# **NCC BUILDING CODE OF AUSTRALIA COMPLIANCE ASSESSMENT**

### **S.456 DA SUBMISSION**

### **PROPOSED CHILD CARE CENTRE**

### **723-727 WARRINGAH ROAD, FORESTVILLE**

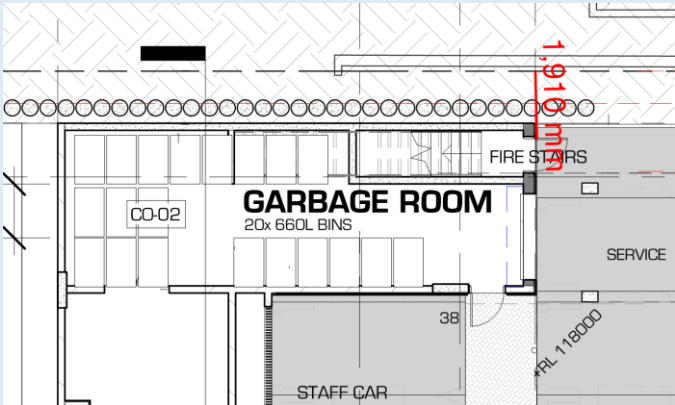
<b>Part C2</b> <b>Compartmentation &amp; Separation</b>					
C2.2 General Floor Area & Volume Limitations	X				Fire compartment floor area and volume limitations do not exceed the limitations set by Table C2.2 for Type A construction.
C2.3 Large Isolated Buildings			X		Not applicable
C2.4 Requirements for Open Space			X		Informational clause only
C2.5 Class 9a & 9c Buildings			X		Not applicable
C2.6 Vertical Separation of openings in				X	<p>This clause applies where the building is not sprinkler protected -</p> <p>All openings located in the external walls of the building</p>

BCA DEEMED-TO-SATISFY PROVISION	COMPLIES	DOES NOT COMPLY	Informational NA or	Compliance Required	COMMENTS
external walls					<p>above one another must comply with vertical separation requirements as stipulated under Clause C2.6, that is:</p> <ul style="list-style-type: none"> <li> <b>Vertical spandrel</b> - They are protected with a 900mm high (FRL 60/60/60) spandrel extending at least 600mm above the separating slab (as per below), or           </li> </ul>  <ul style="list-style-type: none"> <li> <b>Horizontal projecting slab</b> - They are provided with a 1.1m horizontal projection (FRL 60/60/60) also extending at least 450mm either side of the opening.           </li> </ul> <p>Particular attention should be paid to openings being protected via a balcony slab to ensure that the slab extends outwards 1.1m.</p>  <p><b>Details demonstrating compliance with this clause must be incorporated into the construction certificate plans / specification</b></p>

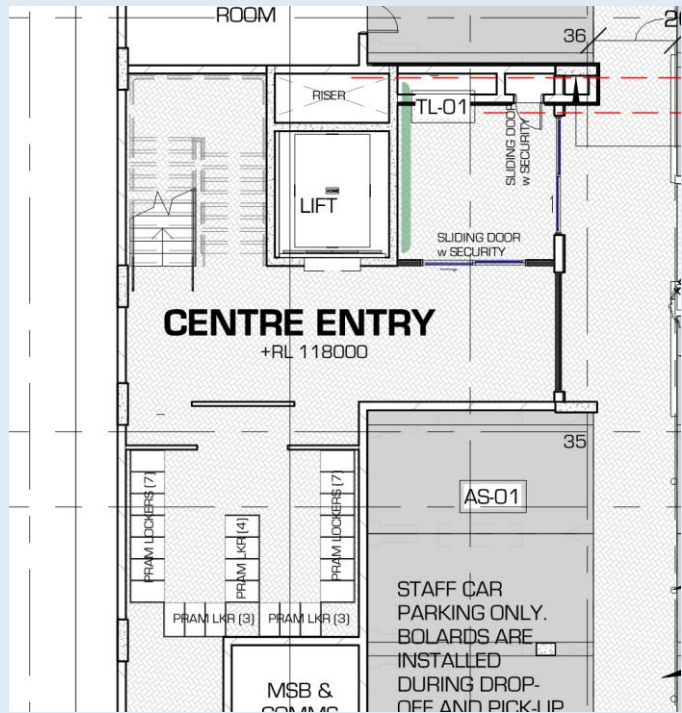
C3.5 Doorways in Fire Walls			X		Not applicable – there are no proposed fire walls.
C3.6 Sliding Fire Doors			X		Not applicable - no sliding fire doors proposed.
C3.7 Protection of Doorways in horizontal exits			X		Not applicable - no horizontal exits proposed.
C3.8 Openings in fire isolated exits				X	<p>Doors to fire stairs must be self or auto closing -/60/30 fire doors.</p> <p><b><i>Details demonstrating compliance with this clause must be incorporated into the construction certificate plans / specification</i></b></p>
C3.9 Service Penetrations in fire-isolated exits				X	<p>The fire isolated exits are not to be penetrated by any services <b>other</b> than water supply pipes for fire services OR electrical wiring associated with:</p> <ul style="list-style-type: none"> <li>• a lighting, detection, or pressurization system serving the exit; or</li> <li>• a security, surveillance or management system serving the exit; or</li> <li>• an intercommunication system or an audible or</li> </ul>

BCA DEEMED-TO-SATISFY PROVISION	COMPLIES	DOES NOT COMPLY	Informational NA or	Compliance Required	COMMENTS
					<p>visual alarm system in accordance with D2.22 (it is noted that re-entry from fire-isolated exits will not be required); or</p> <ul style="list-style-type: none"> <li>the monitoring of hydrant or sprinkler isolating valves</li> </ul> <p><b>Details demonstrating compliance with this clause must be incorporated into the construction certificate plans / specification</b></p>
<p>C3.10 Openings in Fire isolated lift shafts</p>				X	<ul style="list-style-type: none"> <li>Lifts landing doors are required to be fire doors with an FRL of -/60/- that comply with AS 1735.11-1986, and be set to remain closed except when discharging or receiving, passengers, goods or vehicles.</li> <li>Lift indicator panels must also be fire rated in accordance with this clause.</li> </ul> <p><b>Details demonstrating compliance with this clause must be incorporated into the construction certificate plans / specification</b></p>

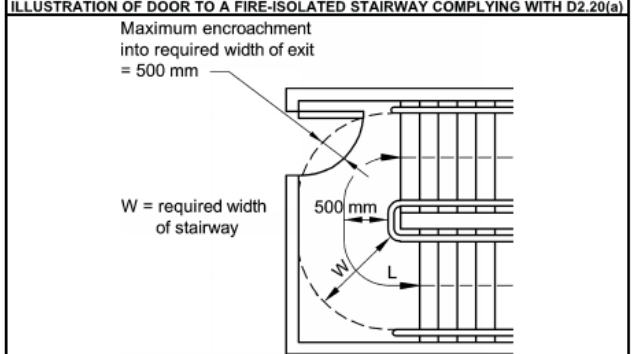
D1.18 Early childhood centres		X			<p>(a) Every part of a Class 9b early childhood centre must be wholly within a storey that provides direct egress to a road or open space.</p> <p>(b) The requirements of (a) do not apply in a building with a rise in storeys of not more than 2, where the Class 9b early childhood centre is the only use in that building.</p> <p><b><u>DTS Compliance matters -</u></b></p> <ul style="list-style-type: none"> <li>• <b>The building has a RIS of 3 service by 2</b></li> </ul>

BCA DEEMED-TO-SATISFY PROVISION	COMPLIES	DOES NOT COMPLY	Informational NA or	Compliance Required	COMMENTS
					<p>required exits on L1 &amp; L2.</p> <ul style="list-style-type: none"> <li>As L1 &amp; L2 do not provide direct egress to road or open space occupant egress must be assessed under a fire engineered solution at CC stage to demonstrate compliance with the relevant Performance Requirements of the BCA.</li> </ul>
<b>Part D2</b> <b>Construction of Exits</b>					
D2.2 Fire-Isolated stairways and ramps				X	<p>The fire isolated stairways must be constructed of non-combustible materials and constructed so that if there is local failure it will not cause structural damage to, or impair the fire-resistance of the shaft.</p> <p><b><i>Details demonstrating compliance with this clause must be incorporated into the construction certificate plans / specification (and structural details)</i></b></p>
